Technical Bulletin

New Drip Pan Pennant Plates

FM-7.5-215
Rev A
08-17-06

Fig. 1

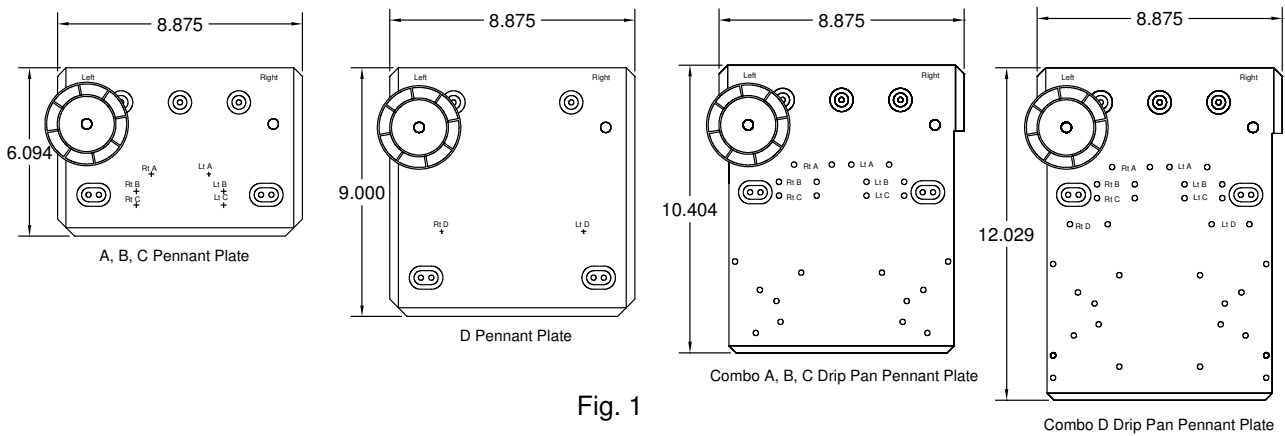
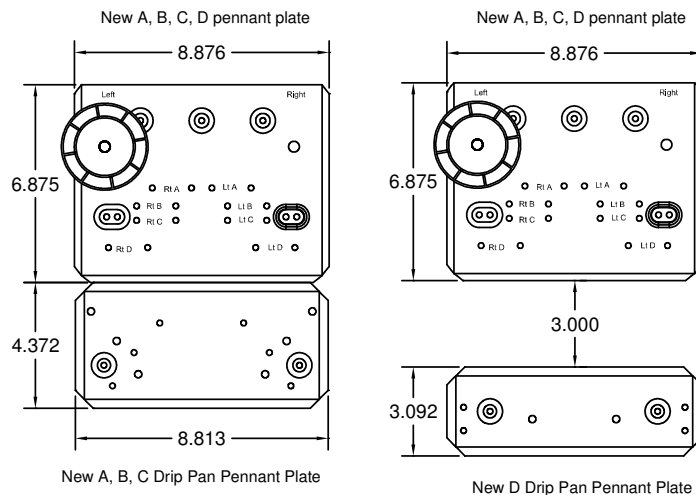
R·O·M is pleased to announce the consolidation of our pennant plate inventory. R·O·M Series III Shutters will now come standard with 12 ga pennant plates, eliminating the need to order "heavy duty" pennant plates. The new pennant plate will now accommodate size A, B, C and D roll sizes and for your convenience the mounting holes have not changed. Along with our consolidation of our pennant plate inventory we will also change the way we handle drip pans. In place of the combination pennant plate/drip pan plates you will receive a pennant plate for the shutter and a separate pennant plate for the drip pan, Fig. 1 shows examples of pennant plate for the shutter and drip pans you have received in the past.

While Fig. 2 shows the pennant plates you will be receiving on future orders and how they should be mounted in your compartment.
